Peer Review File

Hydropower capacity factors trending down in the United States

Reviewers' Comments:

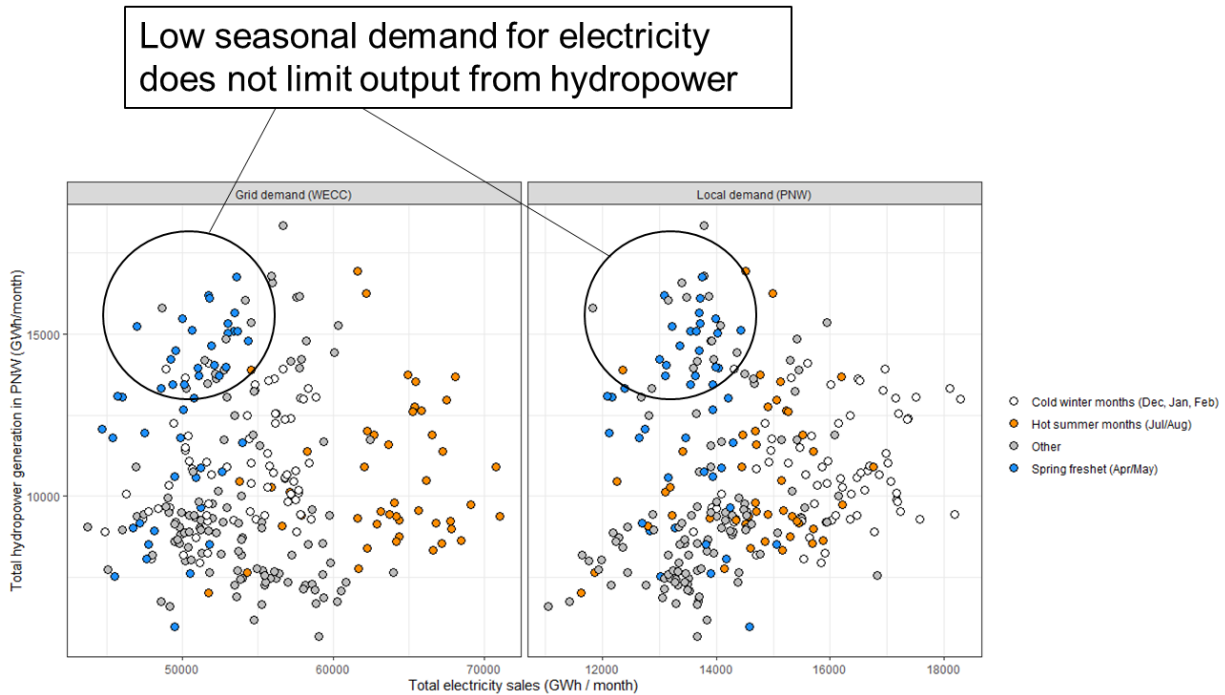
R1-12: L85: *again to the question of whether this is partly due to **demand patterns**, did you confirm that the water is available at **times when it is actually useful**? E.g., high winter water availability might not lead to much use given lower winter demand so far, but it's also useful to flag seasonality mismatches because of dynamics like an expectation that we'll move to winter peaking as heating electrifies (which could make these dams extremely valuable).*

Authors' response: The above comments suggest a link between seasonal electricity demand and total output from hydropower, implying that the former affects the latter. While such a link is intuitive, the reality is that output from U.S. hydroelectric power plants is insensitive to typical demand fluctuations at seasonal timescales. Hydropower generation often follows load (or price) at sub-daily (sometimes sub-weekly) timescales. But at monthly, seasonal, or annual timescales, total generation follows water availability, not demand. Some explanation and demonstration of this phenomenon follow.

dams on the Columbia and Colorado river systems generate power from the Spring runoff of melting mountain snow. When the reservoirs are full and hydroelectric plants are generating plentiful amounts of power, there is not enough local demand to use the supply. Since hydropower was cheaper than any alternative, long distance transmission lines were built to deliver the excess power from the Northwest and Southwest to load centers in California” (FERC, 2023).

Hydropower has almost no marginal production costs, so generation remains profitable even during periods of low demand and low prices. Moreover, hydropower operators are often obligated to release water according to the reservoir management rules designed for non-power objectives, such as complying with flood control curves, or maintaining a minimum flow downstream. Since the water must be released, hydropower plants will tend to generate with as much of it as possible, irrespective of electricity price. They may try to shape generation to balance short-term load and maximize revenues, but the overall generation within a month is not a function of total demand. This contrasts with technologies with high fuel costs or other marginal costs; such technologies have a disincentive to generate when prices are low. Fuel not used during low price periods can be stored for later use; it’s not lost to spill as with hydro. Even in the Northwest, where hydropower represents a very large proportion of generating capacity, the low demand season (spring) coincides with the highest output from hydropower units due to high flows driven by snowmelt. If the potential generation exceeds local demand, hydropower will be produced and exported elsewhere in the Western grid.

Since this issue was highlighted as a main concern, we have decided to back up our reasoning with some further analysis. Below we show data for the Pacific Northwest (PNW) to demonstrate the disconnect between electricity demand and hydropower output—even in this area where hydropower dominates electricity supply.

Actions taken: We have added to discussion a detailed explanation for not considering possible seasonal electricity demand patterns as a driver of annual CF trend (LINES 513-532).

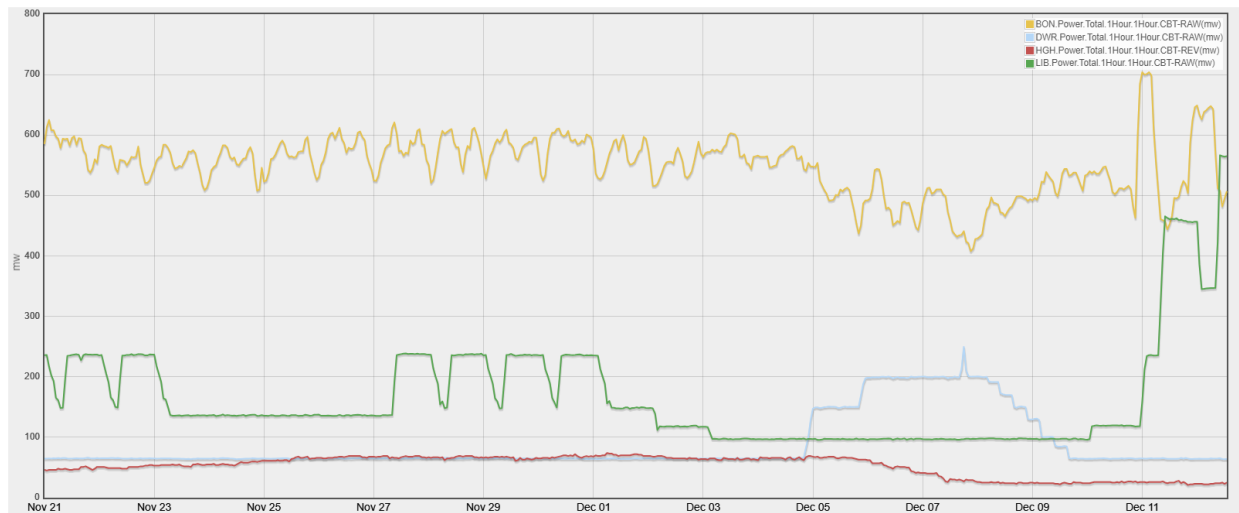
R2-7: *Just like the low capacity factor of peak generating gas turbine is the result of their ability to provide power when needed and stay idle when the demand decreases or the supply ramps up, the same is true for hydropower, so the decline have less or nothing to do with the availability of the resources, but utilizing its flexibility in providing power as needed. Low capacity factor of solar and wind is a measure of their failure to serve their purpose.*

Authors' response: Whether a hydropower plant is operated as a peaking plant or not, annual energy output from that plant, and long-term trends in annual energy output, remain an interesting and important metric for a variety of reasons. As reflected in Reviewer 3's insightful comment (**R3-5**), the hydropower community has long suspected that the introduction of the Electric Consumers Protection Act of 1986 resulted in impaired generation and CF at peaking plants. Our study offers new and compelling evidence of such declines across a large sample of plants. Furthermore, whether a plant is operated as a peaking plant or not, long-term change in water availability will certainly affect annual output. Peaker or not, almost no hydropower plants show annual output that is uncorrelated with annual reservoir inflow.

Incidentally, your description of hydropower plants as able to provide power when needed has been a lively subject of research in recent years. This is how hydropower has been represented in power system models that simulate generators dispatching to the grid (e.g., PLEXOS, GridView); one assigns the hydropower plant monthly energy budgets to reflect the amount of energy available, and the model dispatches power as needed to balance variable resources and promote an efficient and reliable power grid. Unfortunately, this representation of hydropower does not reflect reality. As discussed in detail by Marshall and Grubert (2022) as well as Rheinheimer et al. (2023)—and demonstrated through numerical experiments by Magee et al. (2022)—hydropower plants are rarely able to serve the electric grid in the way a gas peaking plant does. Most dams serve non-power objectives that dominate the release of water, such as complying with flood control rules, fish passage regulations, meeting downstream dissolved oxygen needs, and so on. Those constraints will require a certain volume of water released over a day, week, or month, and hydropower plant operators need operate within those boundaries. Many plants are unable participate whatsoever as flexible resources, due to downstream environmental, safety, amenity, and recreational risks associated with ramping up and down the release of water (Dworshak and Hungry Horse provide nice examples of this—see graph below and note Reviewer #3's comments on ramping restrictions in **R3-4**). Run-of-river facilities may have storage in the order of hours only and are therefore generating whatever portion of flow they can. Anything not turbined is spilled (meaning lost energy and lost revenue). See the example of Bonneville, below. Note that shaping the generation to meet load is often impossible in such systems, since there are multiple plants in cascade, and the power generated from one will dictate the when the flow arrives to the next (e.g., see the PNNL 2021 Hydropower Value Study showing how run of river facilities downstream of Grand Coulee are essentially generating whenever the outflows from the upstream projects arrive). Even plants that serve as peaking plants do not behave in the same fashion as a gas peaker. For example, see Libby below (a

peaking plant, according to the Existing Hydropower Assets database)—there’s somewhat of a diurnal ramp-up for daytime loads, but the plant is ramping from ~130MW to 220MW; the plant does not sit idle. Gas peaking plants don’t lose their fuel when not operating, whereas hydropower plants stand to lose their resource (via spill) if they don’t generate.
